INITIAL FIRE SAFETY INSPECTION REPORT

Graphics Textiles Ltd. (Extension-2)

RSC ID: 26357

Date: 01 July, 2025

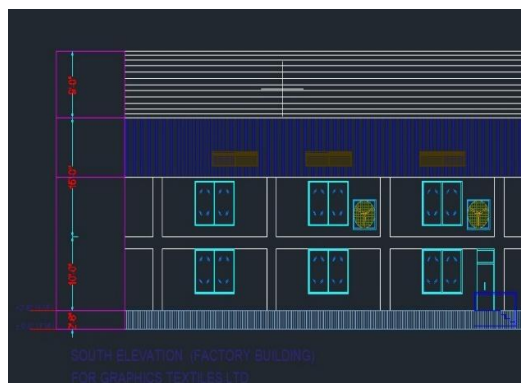
Sly No.	Category	Findings	Required Action	Remediation Time Frame
F1	Fire Rated Construction (Passive Fire Protection of Steel Structure)	The main structural element of the new building (on 1st floor) is constructed by steel which is non-rated and were found in exposed condition without any fire protection. Location: 1st floor of Building-8: Printing Building (G+1) Height of Building Peak: 11.12m	The construction type shall confirm to be in accordance with BNBC 2020 Part-3, Table 3.1.7. Ensure fire resistive rated construction following Table 3.3.1 (a) Part 3 Section-3, Table 3.2.2 and Table 3.2.3 Part 3 Section 2 and Table 4.1.1 from BNBC 2020 Part 4 Section 1. Provide design philosophy to determine the construction type as per BNBC 2020. If any construction rating requires, Consult a qualified fire protection engineer to achieve the require fire rating. Submit the design philosophy along with the required documents to RSC for review the required construction type. Once the design philosophy is reviewed, provide fire ratings of structural members.	Within 6 Months

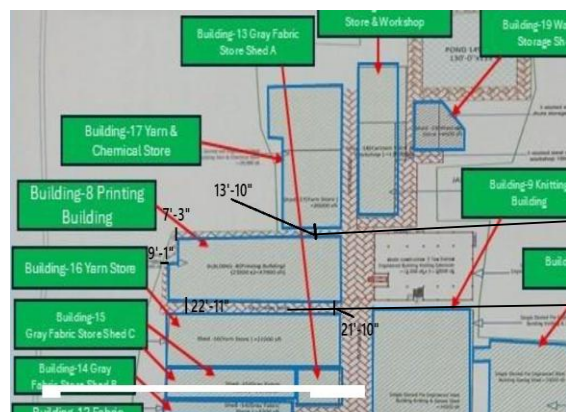
Sly No.	Category	Findings	Required Action	Remediation Time Frame
F2	Fire Rated Construction	The required fire separation distance for Building-8: Printing Building does not comply with the requirements of BNBC 2020. Location: Building-8: Printing Building.	The exterior walls shall have a fire resistance and opening protection as specified in BNBC 2020 Part 3 Section 2.4.1.3. Table 3.2.2 & 3.2.3 and BNBC 2020 Part 3 Table 3.3.1 (a)	Within 6 Months

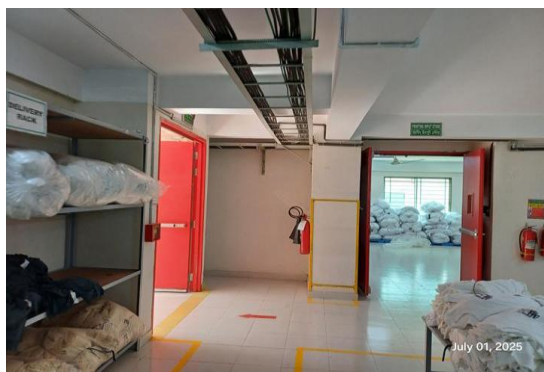
Sly No.	Category	Findings	Required Action	Remediation Time Frame
F6	Fire Rated Construction	Rooms used for storage of combustible materials are not separated from the surrounding occupancy. Location: Ground floor of Building-8: Printing Building. Non-compliance reason: (i) Unprotected penetration/opening on rated wall. (ii) Unavailability of datasheet and certificate of all parts of fire door and (iii) The fire doors at the store are not interfaced with the fire alarm & detection system.	Rooms used for storage of combustible materials shall be separated from the surrounding occupancy with a minimum 1 hour construction in accordance with section 3.4.2.1.5 of RSC Technical Guideline (Standard). Seal all penetrations and openings in fire rated assemblies by a listed through-penetration fire stop system tested in accordance with ASTM E814 or approved alternative standard to maintain minimum 1-hr. fire resistance rating. Installation shall be as per manufacturer published installation guideline and the certification authority guideline to ensure the fire-rating in accordance with section 4.7 of RSC Technical Guideline (Standard)	Within 3 Months

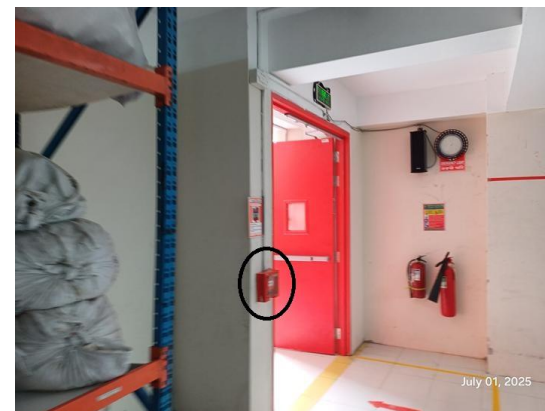
Sly No.	Category	Findings	Required Action	Remediation Time Frame
F9	Fire Alarm & Detection system	The factory has installed a fire alarm and detection system that requires a detailed review to confirm compliance with NFPA 72 and RSC Technical Guidelines (Standard). Location: Building-8: Printing Building.	Submit the fire alarm and detection system design to RSC for review. Once the design is reviewed, install and modify the fire detection and alarm system throughout the building in accordance with review comment, RSC Technical Guidelines (Standard) and NFPA 72. After installation the owner shall conduct internal testing and commissioning and then contact the RSC for witness of final acceptance testing.	Design within 2 Months and modification/ installation with 4 Months

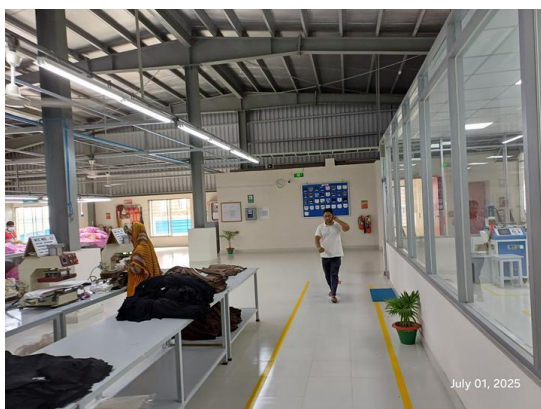
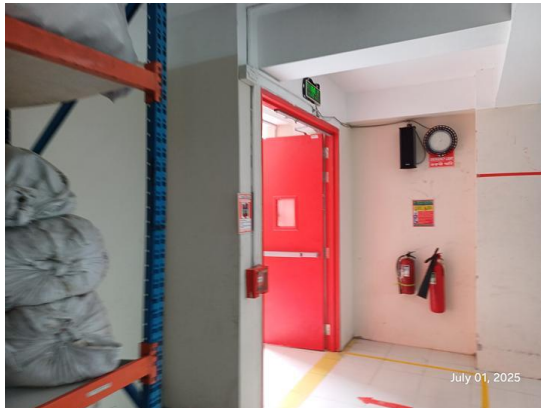
Sly No.	Category	Findings	Required Action	Remediation Time Frame
F18	Means of Egress	Directional signs are not provided where direction of the path of travel to an exit has changed. Location: Both floors of Building-8: Printing Building.	Illuminated directional signs shall be provided where there is a change in the direction for the path of travel and the direction to an exit is not obvious in accordance with RSC Technical Guidelines (Standard)¹ V1.0 Section 6.11.3.	Within 1 Month

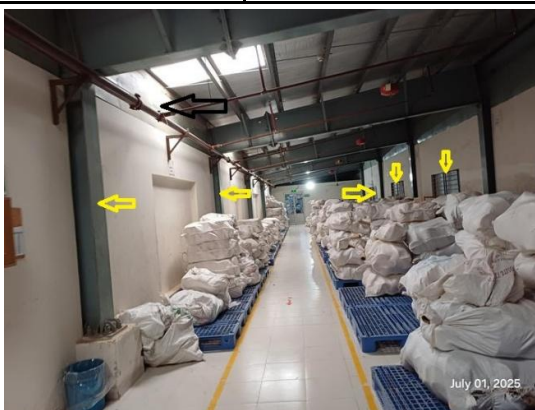
SI No.	Category	Findings	Required Action	Remediation Time Frame
F26	Fire Rated Construction	Rooms used for storage of combustible materials are not separated from the surrounding occupancy. Location: Mezznine floor finished goods store, ground floor store in Building-9: Knitting Shed. Non-compliance reason: (i) Fire rated construction is not provided, (ii)Unprotected penetration/opening on rated wall. (iii) unprotected steel structural element.	Rooms used for storage of combustible materials shall be separated from the surrounding occupancy with a minimum 1 hour construction in accordance with section 3.4.2.1.5 of RSC Technical Guideline (Standard). Seal all penetrations and openings in fire rated assemblies by a listed through-penetration fire stop system tested in accordance with ASTM E814 or approved alternative standard to maintain minimum 1-hr. fire resistance rating. Installation shall be as per manufacturer published installation guideline and the certification authority guideline to ensure the fire-rating in accordance with section 4.7 of RSC Technical Guideline (Standard)	Within 3 Months

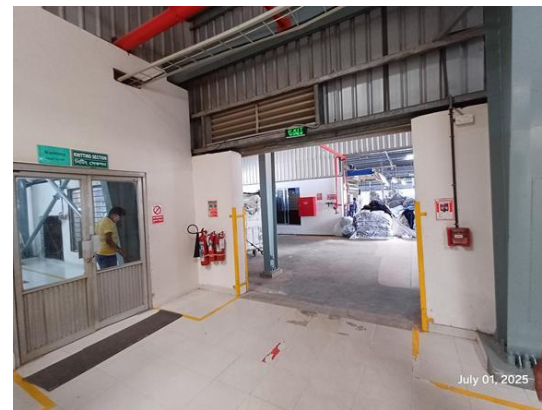
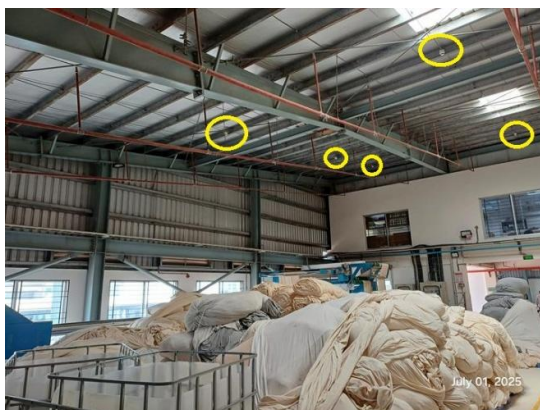
SI No.	Category	Findings	Required Action	Remediation Time Frame
F28	Fire Alarm & Detection system	The factory has installed a fire alarm and detection system that requires a detailed review to confirm compliance with NFPA 72 and RSC Technical Guidelines (Standard). Location: Building-9: Knitting Shed.	Submit the fire alarm and detection system design to RSC for review. Once the design is reviewed, install and modify the fire detection and alarm system throughout the building in accordance with review comment, RSC Technical Guidelines (Standard) and NFPA 72. After installation the owner shall conduct internal testing and commissioning and then contact the RSC for witness of final acceptance testing.	Design within 2 Months and modification/ installation with 4 Months

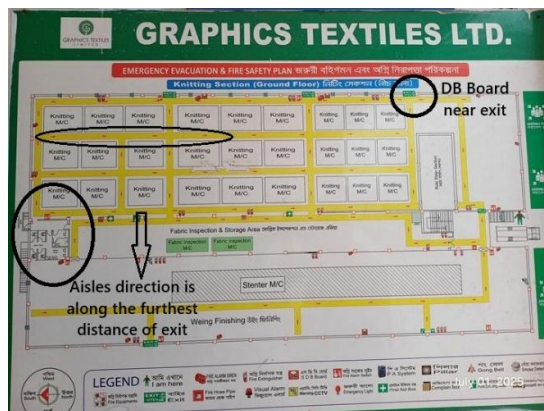
SI No.	Category	Findings	Required Action	Remediation Time Frame
F32	Means of Egress	The maximum travel distance exceeds 45 m which does not meet the requirements of Section 6.13 of RSC Technical Guidelines (Standard). Location: Knitting Section on ground floor of Building-9: Knitting Shed. Available travel distance: 165 ft (50.29m)	Reconfigure the egress arrangement to meet 6.13 of RSC Technical Guidelines (Standard). Or, Provide additional exits so that the travel distance shall not exceed the maximum allowable limit. Or, Provide Sprinkler System or FADS along with standby system to meet the requirement of maximum travel distance.	Within 3 Months

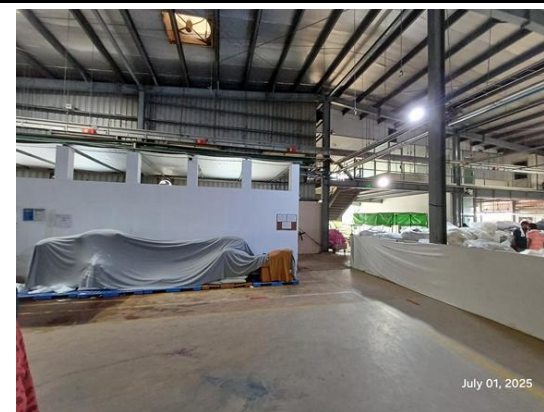
SI No.	Category	Findings	Required Action	Remediation Time Frame
F38	Means of Egress	Based on the number and location of emergency lights observed, adequate illumination levels are not anticipated along egress routes. Location: Building-9: Knitting Shed.	Test the emergency lighting system on each floor and provide additional emergency fixtures to provide adequate illumination along the means of egress. Provide a minimum illumination of 10 lux at the floor level within exit stairs and exit discharge paths and minimum 2.5 lux along exit access aisles. Illumination on means of egress shall meet in accordance with RSC Technical Guidelines (Standard)¹ V1.0 Section 10.12.2.	Within 3 Months

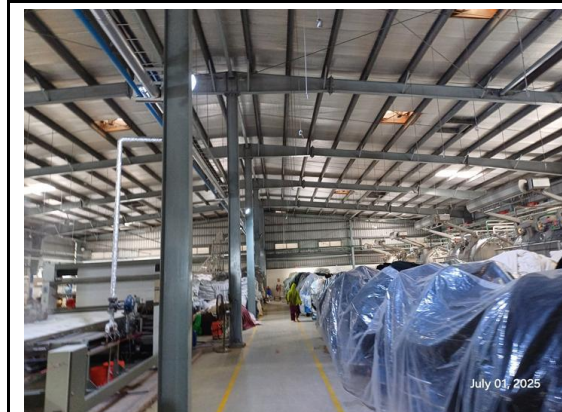
SI No.	Category	Findings	Required Action	Remediation Time Frame
F43	Fire Rated Construction	The required fire separation distance for Building-10: New Dyeing Shed does not comply with the requirements of BNBC 2020. Location: Building-10: New Dyeing Shed.	The exterior walls shall have a fire resistance and opening protection as specified in BNBC 2020 Part 3 Section 2.4.1.3. Table 3.2.2 & 3.2.3 and BNBC 2020 Part 3 Table 3.3.1 (a)	Within 6 Months

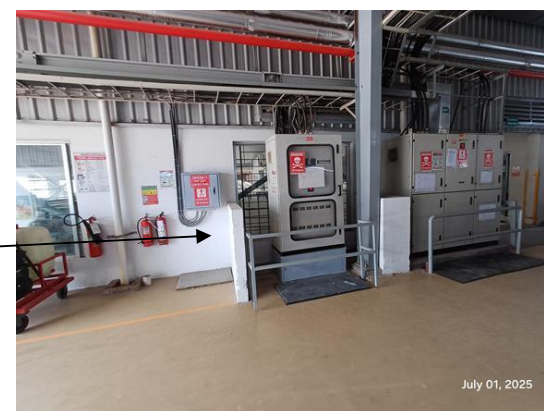
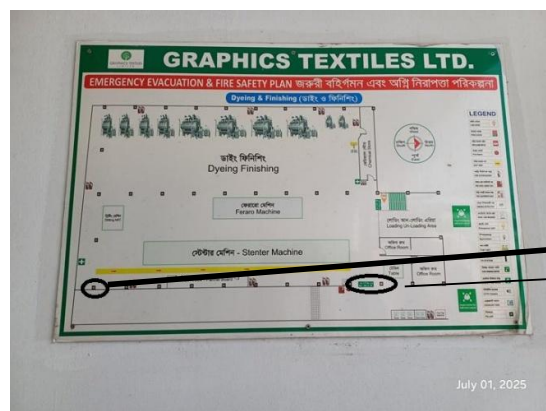
SI No.	Category	Findings	Required Action	Remediation Time Frame
F45	Means of Egress	Electrical panels and in-process storage were located in the north-east exit discharge and N-E & S-E exit discharge respectively. Location: Building-10: New Dyeing Shed.	Remove and re-locate all Electrical panels/ In-process storage from exit discharge. Or, Provide fire separation to exit passageway in accordance with section 6.15 of RSC Technical Guidelines (Standard)¹ V1.0.	Within 3 Months

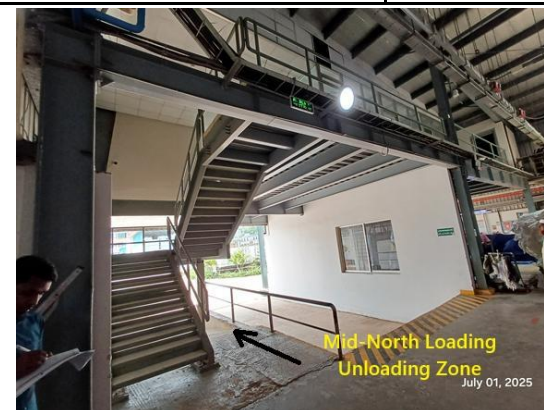
SI No.	Category	Findings	Required Action	Remediation Time Frame
F46	Means of Egress	Exit access corridor(s) serving more than 30 occupants is not separated by fire rated construction or protected by sprinkler system in accordance with NFPA 13 and section 6.3.1.1 of RSC Technical Guidelines (Standard)¹ V1.0. Location: North-east exit discharge, South-east exit discharge and Mid-north exit discharge of Building-10: New Dyeing Shed. Non-compliance Reason: Non-rated partition and unprotected opening in North-east exit discharge; Unprotected opening from toilet zone on south-west exit discharge and open loading-unloading point in mid-north exit discharge.	1. Separate the exit access corridor by a minimum 1-hr fire rated construction . Or 2. Provide automatic sprinkler system throughout the storey as per NFPA 13.	Within 3 Months

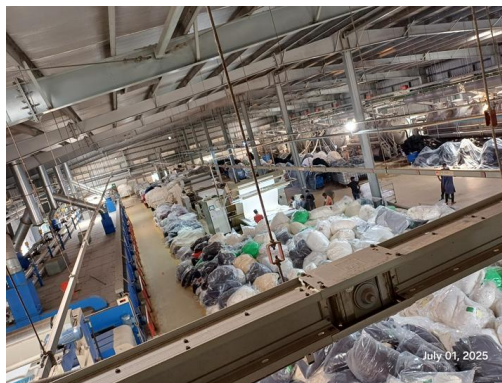
SI No.	Category	Findings	Required Action	Remediation Time Frame
F48	Fire Rated Construction	Areas used for in-process storage of combustible materials are open to the surrounding occupancy. Location: Ground floor of Building-10: New Dyeing Shed.	Provide defined storage areas and limit the storage arrangement as follows: Maximum height of 2.45 m and maximum area of 23 m² and is separated by a minimum 3.0 m (10ft) from other storage areas and they do not exceed 10 percent of the building area of the story in which they occur. or, If sprinkler protected, Maximum height 12 ft (3.66 m) and maximum area of 1000 ft² (93 m²) and separated by a at least 25 ft (7.62 m) and does not constitute more than 10 percent of the building area or 4000 ft² (372 m²) of the sprinklered area, whichever is greater. or, Enclose the storage area from the surrounding occupancy with a minimum 1 hour construction.	Within 3 Months

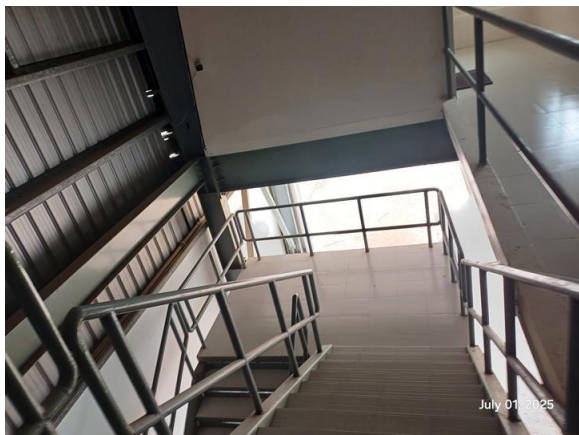
F54	Means of Egress	A single means of exit has been provided for the mezzanine floor. Location: Mezzanine floor of Building-10: New Dyeing Shed. Type of Occupancy: Office; Travel Distance: 92.5 ft (28.19m).	The number of means of egress from any floor, story or portion thereof shall not be less than 2 except where a single exit is permitted by RSC Technical Guideline (Standard)-6.6.2. A single means of egress is permitted by RSC Technical Guideline (Standard)-6.6.5 or where a greater number is required by RSC Technical Guideline (Standard)-6.6.3. Other than single exit permitted by RSC Technical Guideline (Standard), floors shall be kept completely out of bounds for operational activity and remain unused until second exit is ensured.	Within 3 Months

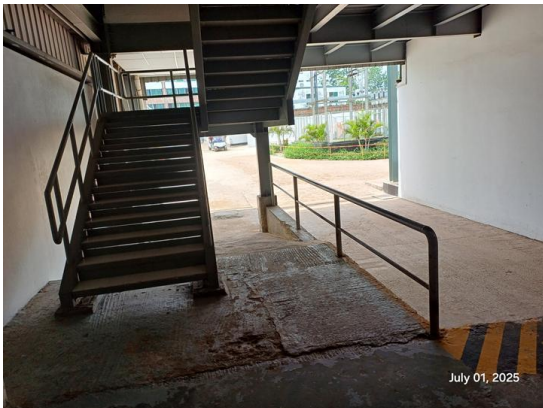
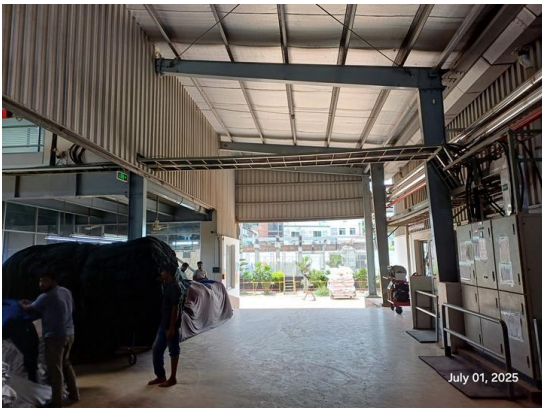
F55	Means of Egress	Handrails are not provided on both sides of each ramps on ground floor extending upto road level. Having ramp width exceeding 2.2m is not provided with intermediate handrail. Location: Ground floor of Building-10: New Dyeing Shed.	Provide handrails on both sides of the exit stair. New handrails shall have a minimum height of 865 mm (34 in.) and a maximum height of 965 mm (38 in.) as measured from the leading edge of the tread. Intermediate handrails shall be provided when the stair width exceeds 2.2 m (87 in.). in accordance with RSC Technical Guidelines (Standard)¹ V1.0 Section 6.10. 3 Open guards shall have intermediate rails or pattern such that a sphere 200 mm (8 in.) in diameter cannot pass through any opening up to a height of 865 mm (34 in.). Handrail shall construct in accordance with RSC Technical Guidelines (Standard)¹ V1.0 Section 6.12.	Within 2 Months

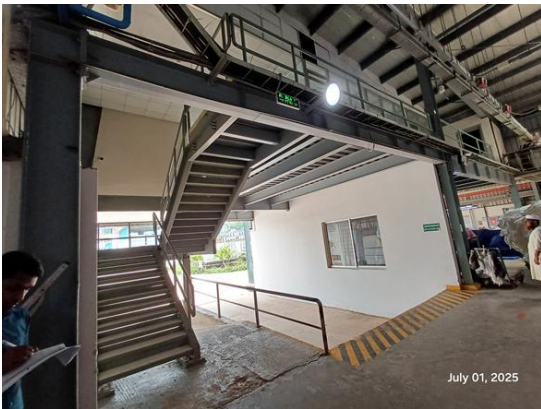
F56	Means of Egress	No guard rail provided for mid-north loading-unloading zone near ramp on ground floor. Location: Building-10: New Dyeing Shed.	Guards shall be provided at all open sides of means of egress that exceed 760 mm (30 in.) above the floor or finished ground below. Guards shall have a minimum height of 1067 mm (42 in.). Open guards shall have intermediate rails or pattern such that a sphere 200 mm (8 in.) in diameter cannot pass through any opening up to a height of 865 mm (34 in.). Guard shall construct in accordance with RSC Technical Guidelines (Standard)¹ V1.0 Section 6.12.	Within 3 Months

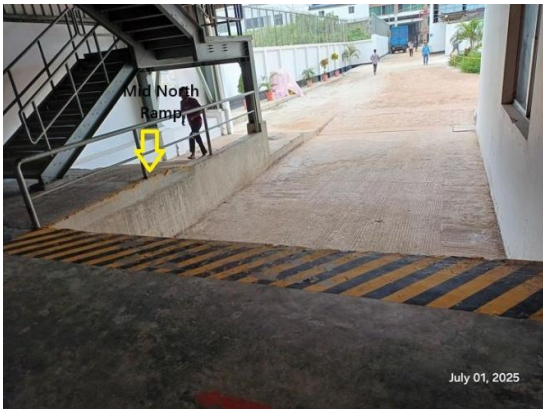
F57	Means of Egress	Changes in level in North-west and mid-north ramp was found 38 in., 38 in. and 39 in. respectively, where RSC Technical Guidelines (Standard)¹ V1.0 Section 6.9 or 6.10 doesn't meet. Location: North-east, South-east and mid-north ramp in Building-10: New Dyeing Shed.	Changes in level exceeding 535 mm (21 in.) in elevation shall meet the requirements for stairs in 6.9 or ramps in 6.10. The change in level shall be readily apparent and if not, marked with additional signage or floor markings.	Within 3 Months

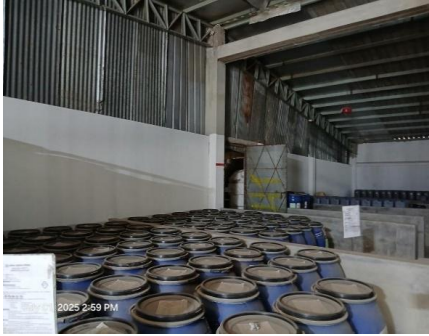
SI No.	Category	Findings	Required Action	Remediation Time Frame
F87	Fire Rated Construction	Rooms used for storage of combustible materials are not separated from the surrounding occupancy/areas. Location: Building-17: Yarn & Chemical Store Shed.	Rooms used for storage of combustible materials shall be separated from the surrounding occupancy with a minimum 1 hour construction in accordance with section 3.4.2.1.5 of RSC Technical Guideline (Standard).	Within 3 months
